***MODIFICATION REQUEST:
Wet 'n' Wild Sydney
Reservoir Road, Prospect
(MP 10_0190 MOD 1)***

Director-General's
Environmental Assessment Report
Section 75W of the
Environmental Planning and Assessment Act 1979

May 2013

Figure 3: Extent of Asbestos Contamination

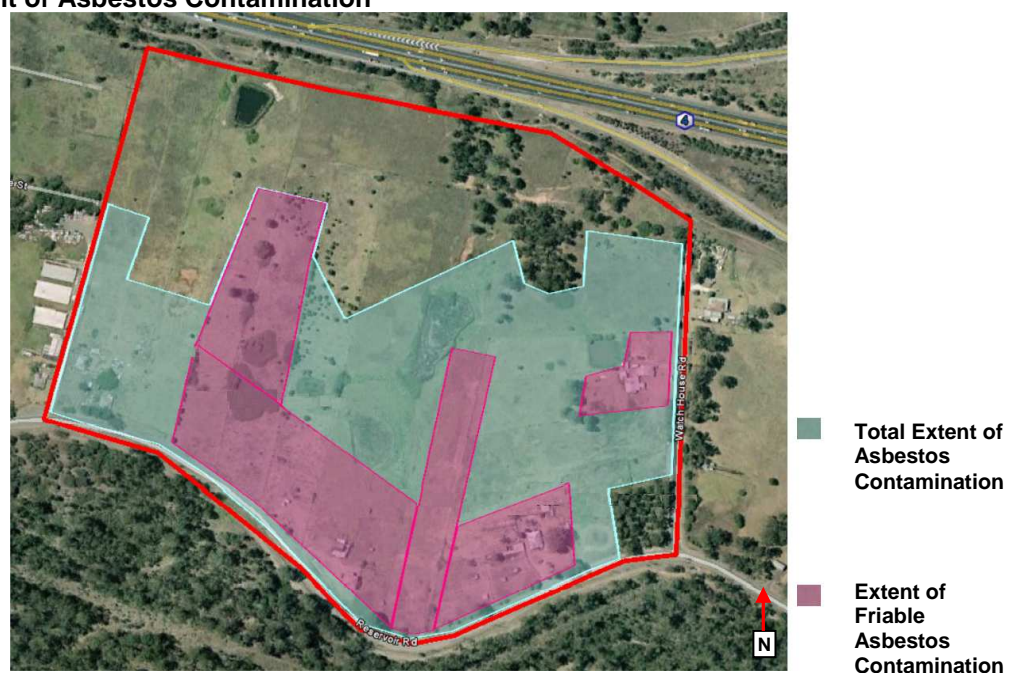
Following approval of the concept plan (MP10_0190) and upon commencement of bulk earthworks on the site in late 2012, asbestos contamination was identified at a number of locations on the site. The identified asbestos contamination included non-friable asbestos (including bonded fragments of asbestos containing cement sheets and plaster board), as well as friable asbestos (clumps of powdery, fibrous, crumbly asbestos containing materials). The total amount of asbestos contaminated soil identified on the site is in excess of 30,000 sqm. The extent of asbestos contamination, including the extent of friable asbestos contamination, is identified in **Figure 3**.

Given the significant amount of asbestos contamination that has been identified at the site during the bulk earthworks stage of the project, the site is now considered to be unsuitable for the proposed use without remediation.

The proponent has therefore lodged a modification application seeking approval to include works associated with the remediation of the asbestos contamination as part of the approval (a further detailed description of the modification application is provided in Section 2 of this report).
